# MANDATORY REFERRAL NO. 2024013 – FLOWER AVENUE SEPARATED BIKE LANES

This is a Mandatory Referral review for the Montgomery County Department of Transportation proposal for separated bike lanes along approximately 0.2 miles of Flower Avenue between Piney Branch Road and Arliss Street, with other pedestrian and bicycle safety improvements.

No. MR2024013

Figure 8: High-Conflict Driveway Southwest of Piney Branch Road

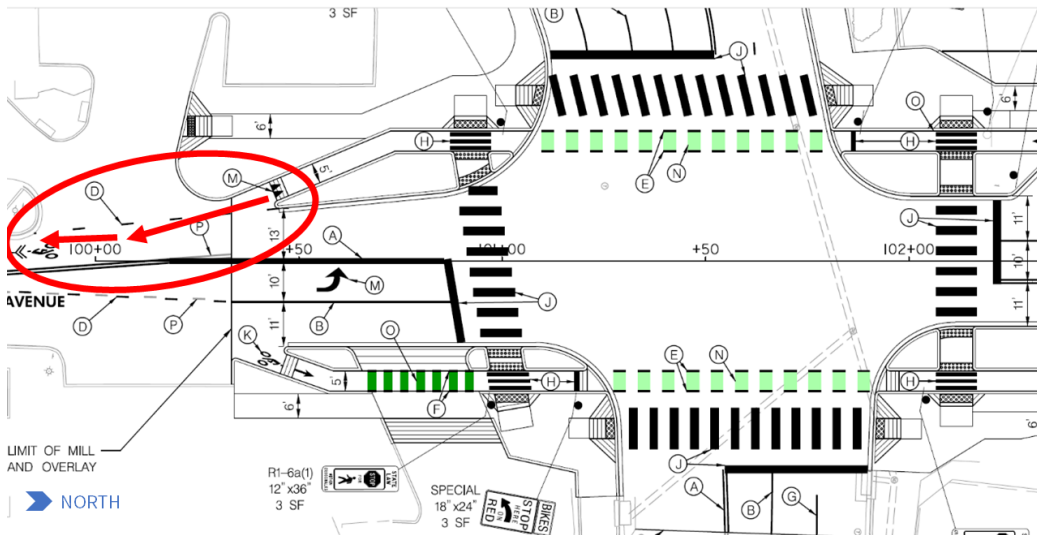
2. Provide green conflict zone striping where the Bike Lane merges with the roadway at the driveway on the west side of Flower Avenue (southbound), south of Piney Branch Road at Station 100+00 (Figure 8). Since the Bike Lane ends abruptly and there are no movement restrictions into or out of the driveway, striping would identify this as a conflict zone to drivers and bicyclists before the roadway gets much narrower south of this location.

Figure 9: Wide Curb Radius at Southwest Corner of Flower Avenue-Piney Branch Road Intersection

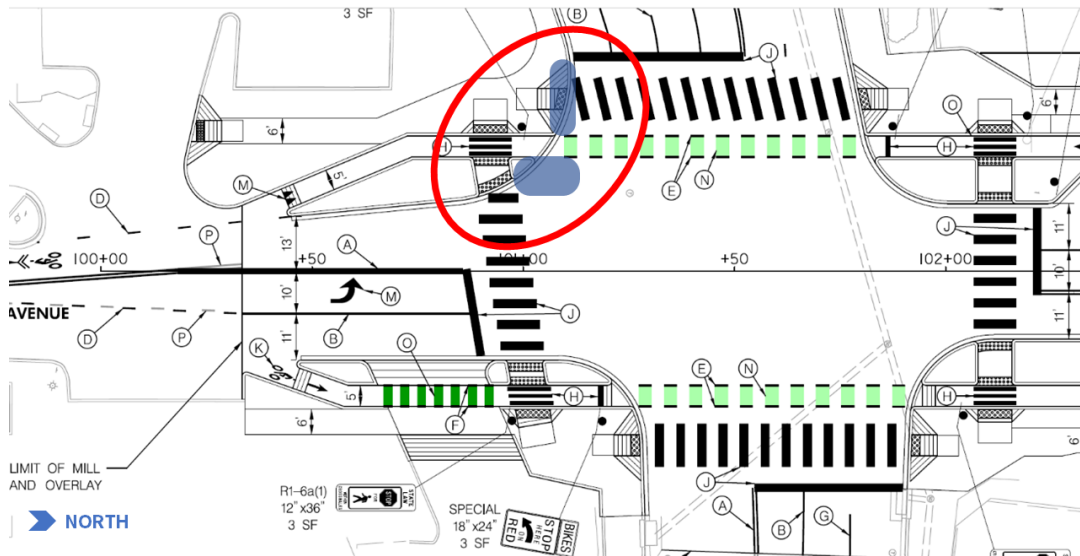
3. Tighten the curb radii at all intersections in line with the 2024 *Complete Streets Design Guide* default radii (15 feet), but especially at the southwest corner of the Piney Branch Road intersection (Figure 9). The Guide states that “designers should assume a maximum 10 miles per hour turning speed for passenger cars and a 5 miles per hour for all other vehicles.” Where wider turning radii may be helpful for larger vehicles or emergency operations, consider the use of mountable curbs or relocating the receiving leg stop bar to allow for encroachment (Figure 10).

Figure 12: Possible Locations for Curb Extensions in the Parking Lanes North of Piney Branch Road

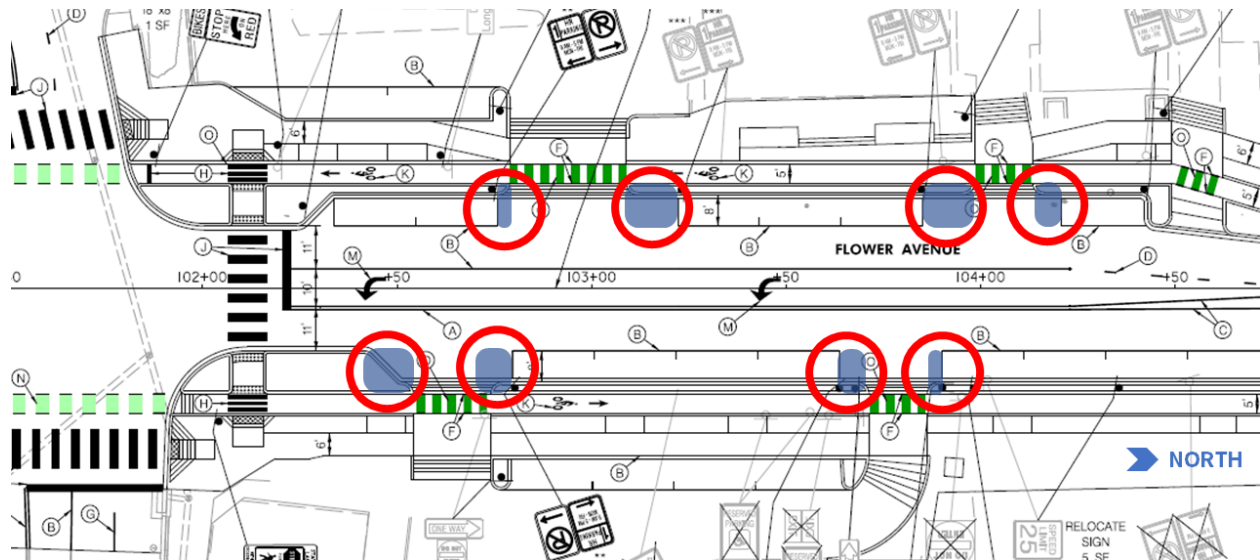
4. **Provide curb extensions into the Parking Lanes on both sides of Flower Avenue just north of Piney Branch Road** (Figure 12). As outlined in the Planning Department’s 2021 *Vision Zero Community Toolkit*, curb extensions can be built in all-day Parking Lanes (Figure 13), and they increase visibility among drivers, bicyclists, and pedestrians and reduce vehicle through and turning speeds. This will enhance safety and prevent vehicles from double parking.

Figure 15: Flower Avenue Segment with Four-Foot Median that Could Shift to Street Buffer Instead

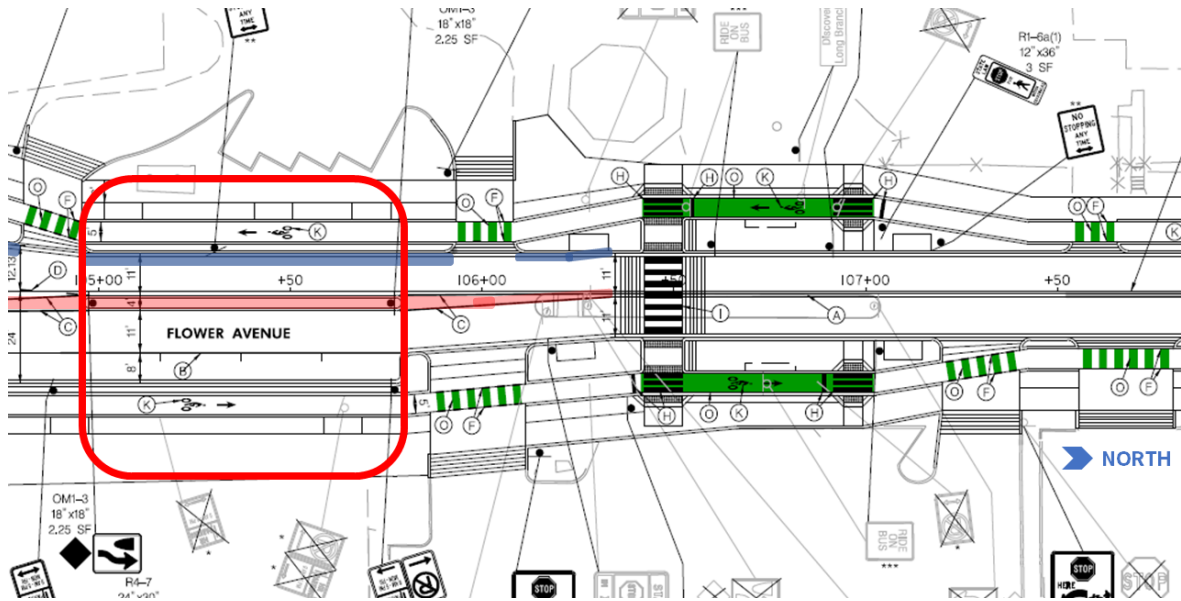
a. **Between Stations 105+00 and 106+50 (Figure 15).**

Figure 16: North End of the Project Area Where Median Could Shift to Street Buffer Instead

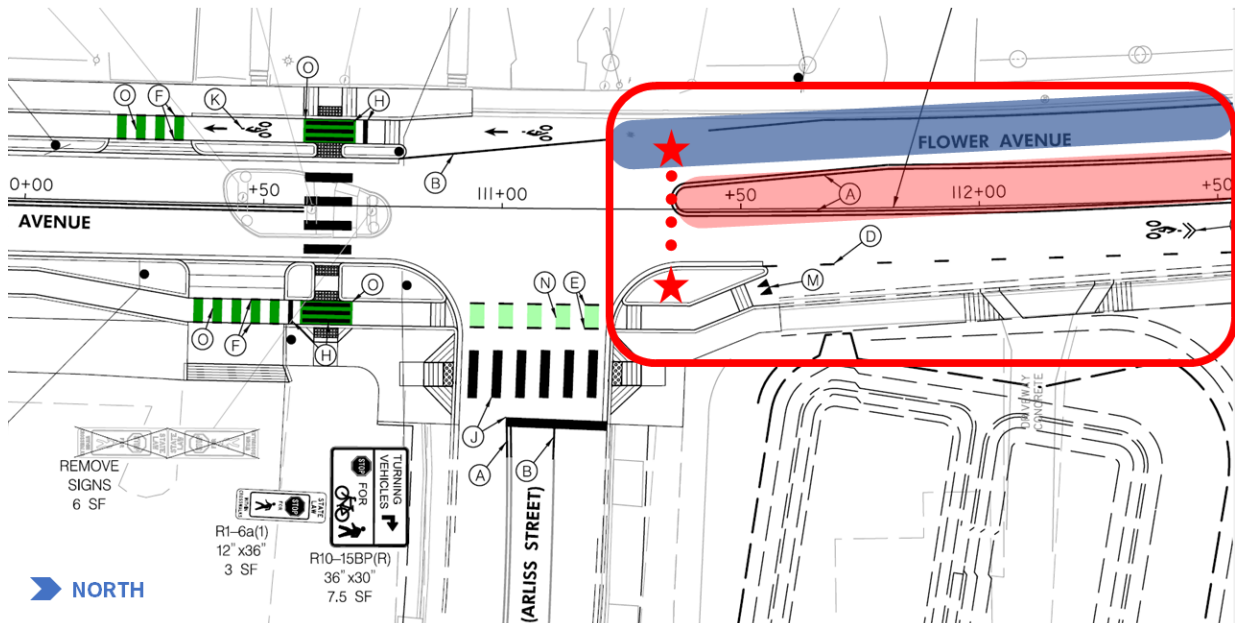
b. **Between Stations 111+25 and 112+50 (Figure 16).**

Figure 17: Narrow Pedestrian Clear Zone at Southeast Corner of Piney Branch-Flower Avenue Intersection

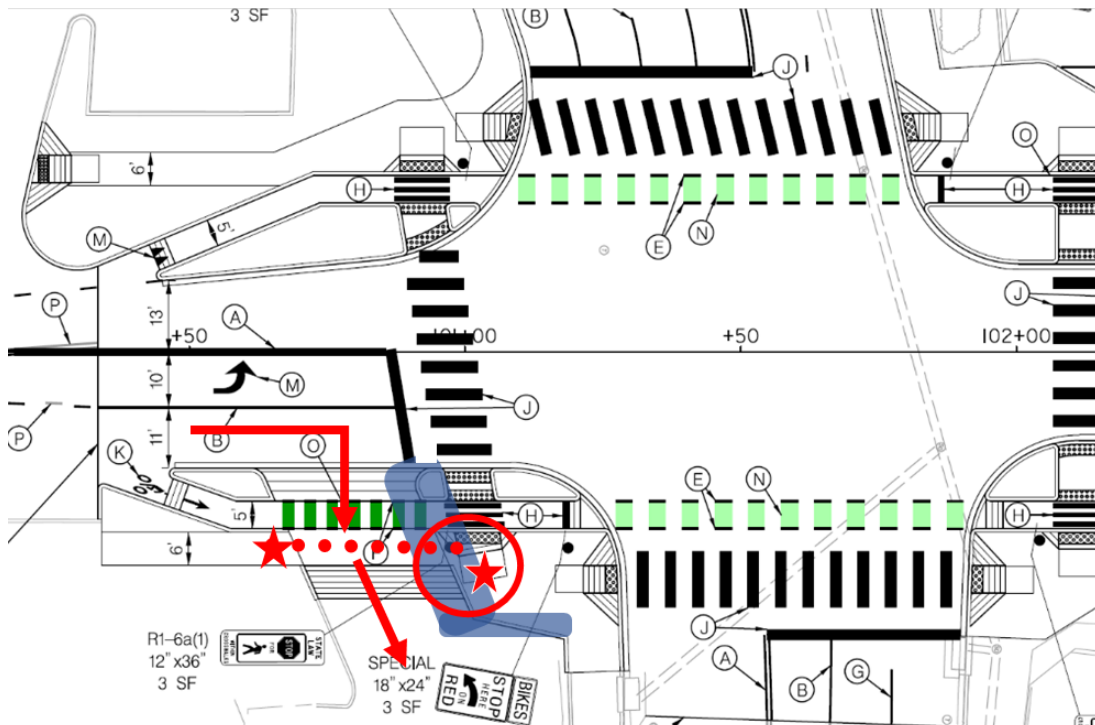
8. **Create ADA accessible space for pedestrians to queue at the southeast corner of the Piney Branch-Flower Avenue intersection by narrowing the parking lot driveway and converting it to right-in only.** There is insufficient landing space to cross the driveway at the southeast corner of the intersection in a wheelchair. Figure 17 shows the proposed pedestrian path as a red dotted

line and the proposed pedestrian landings as red stars; the pathway does not provide a direct connection between the landings. In addition, this driveway is very close to the Piney Branch Road intersection, and it would reduce conflicts among vehicles, bicyclists, and pedestrians if drivers were not trying to enter the roadway from the parking lot driveway. There is a second driveway for this parking lot on Piney Branch Road that drivers can use to safely exit the property.

Figure 18: Sidewalk Segment with Non-Compliant ADA Clear Zone

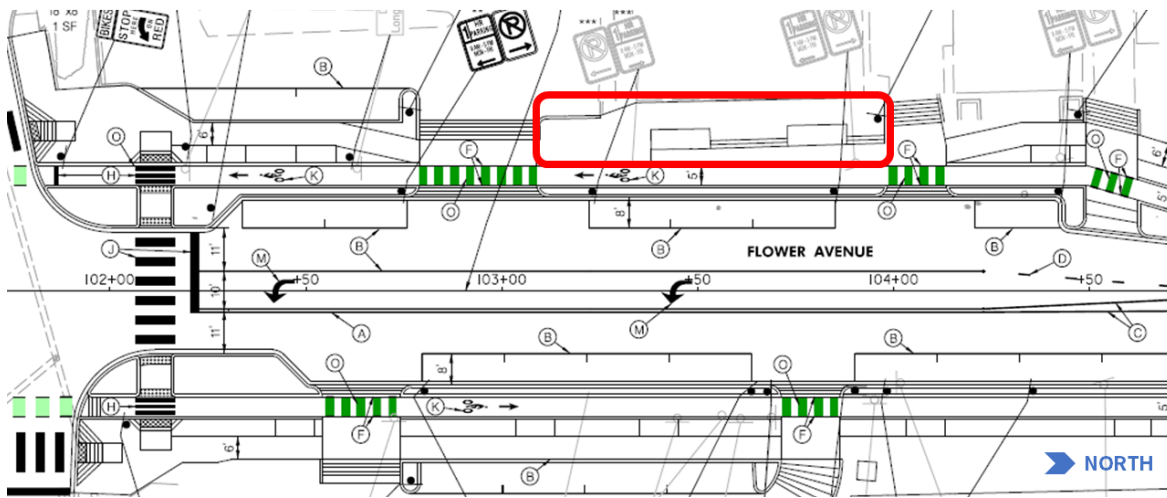
- 9. On the west side of Flower Avenue, between Stations 103+00 and 104+00 (Figure 18), widen the Sidewalk to the 10-foot default width or eight-foot minimum width identified in the 2024 Complete Streets Design Guide and reposition streetlight 207.** At minimum, the Sidewalk should meet the PROWAG-recommended sidewalk width of five feet. The proposed Sidewalk treatment is between 3.5 feet and 4.7-feet-wide because the existing stairs down to the retail storefront will remain (Figure 19). To provide additional space to widen the Sidewalk, either shift the Bike Lane into the on-street parking area or reconfigure the storefront access. For Town Center Streets, on-street parking is a lower priority than bicycle and pedestrian facilities, as outlined in the 2024 Complete Streets Design Guide. In addition, the 2013 Long Branch Sector Plan (p. 44) calls for only one lane of on-street parking on this segment of Flower Avenue. The Applicant should consider removing the west side Parking Lane.

Figure 21: Driveway to One-Way Parking Lot Where Entrance Could Be Narrowed

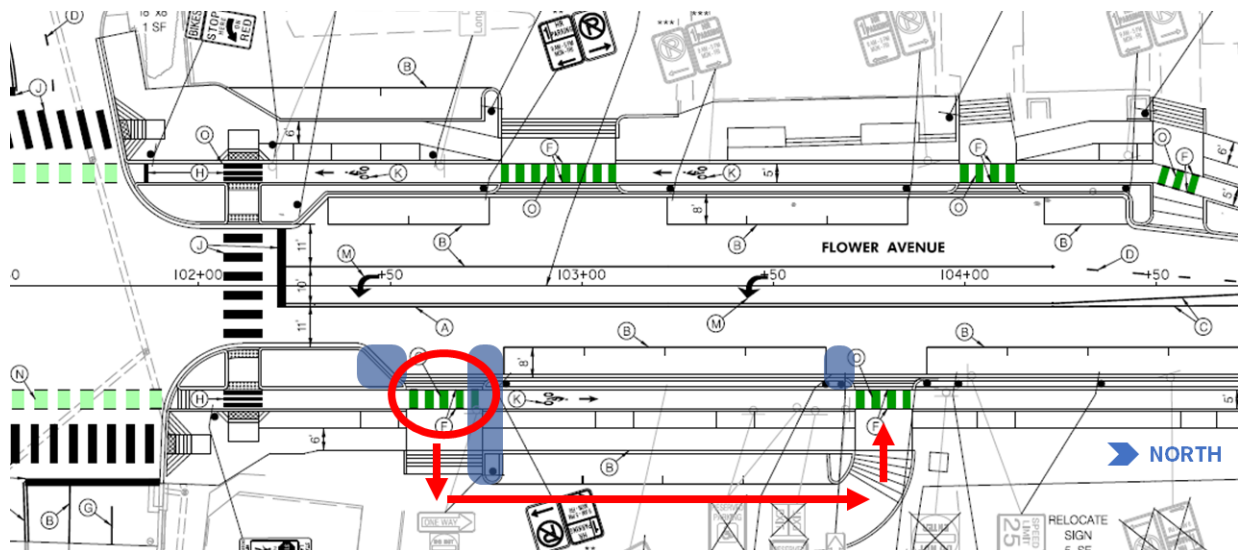
12. **Narrow the entrance driveway on the east side of Flower Avenue at Station 102+75 to, at most, the 15-foot width of the exit driveway at Station 103+75 to reinforce the one-way traffic flow that is proposed (Figure 21).** If the driveway is too wide, drivers may attempt to travel the wrong direction. Also, consider making the southern driveway right-out only to reduce conflicts with the center left turn lane on Flower Avenue.

Figure 22: Driveway North of Piney Branch Road That is a Candidate for Right-Out Only Egress

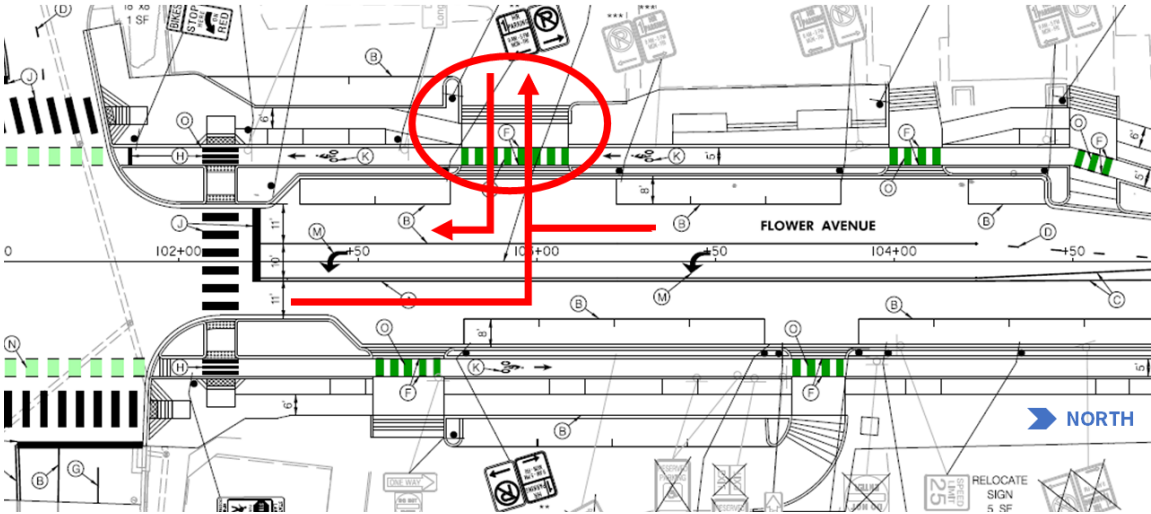
- 13. **Convert the driveway on the west side of Flower Avenue (Stations 102+75/103+00) from full-access to restricted left-out** (Figure 22). Currently, vehicles can exit left or right from the parking lot onto Flower Avenue. There is also another driveway entrance/exit from this parking lot on Piney Branch Road, which has right-only egress. With the addition of the Bike Lane and the proximity to the Piney Branch Road intersection, there is the potential for increased conflict between vehicles, bicyclists, and pedestrians. Restricting traffic movement can limit high-risk conflicts while retaining parking for local retail.

Figure 23: Location Where Bike Lane Could Shift to Provide Vehicle Queuing Space

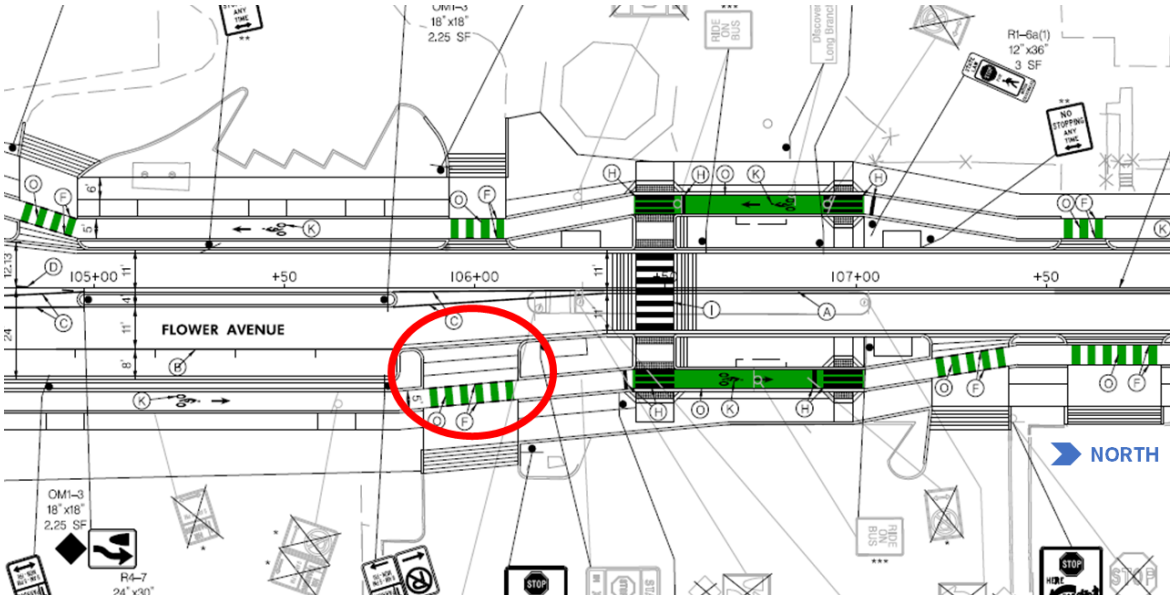
- 14. **Shift the northbound Separated Bike Lane (Station 106+00) further east as it crosses the driveway to allow space for a car to queue between the bikeway and the roadway** (Figure 23). This will limit bikeway encroachment as drivers try to see around the cars parked on-street.

Figure 26: Proposed Project Design Showing the Missing Sidewalk Connection to the Park

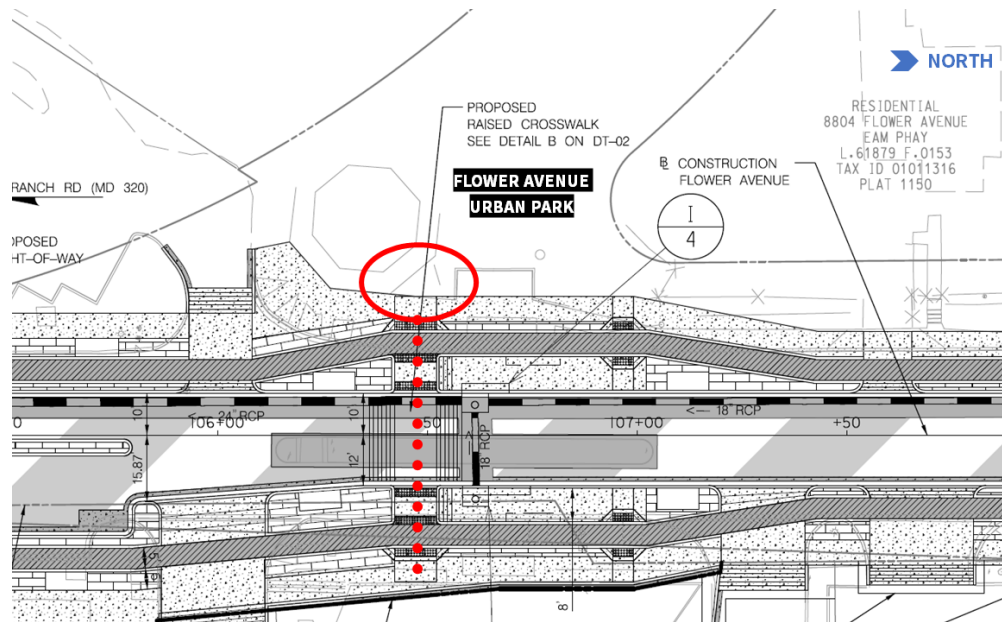
- 17. Provide a continuous sidewalk connection from the bus stop curb ramps at 106+50 directly into Flower Ave Urban Park.** To connect from the park to the proposed bus stop, the proposed design requires pedestrians to zigzag around a small corner of grass where the octagonal entrance to the park meets the sidewalk (Figure 25). Instead, the project should provide a direct connection with a small section of sidewalk to make the proposed sidewalk improvements sympathetic to the park entrance (Figure 26). This area is within the right-of-way and will not require a Park Construction Permit.
- 18. Bollards at the entrance to Flower Ave Urban Park shall be replaced in-kind within the same footprint of the new sidewalk.**
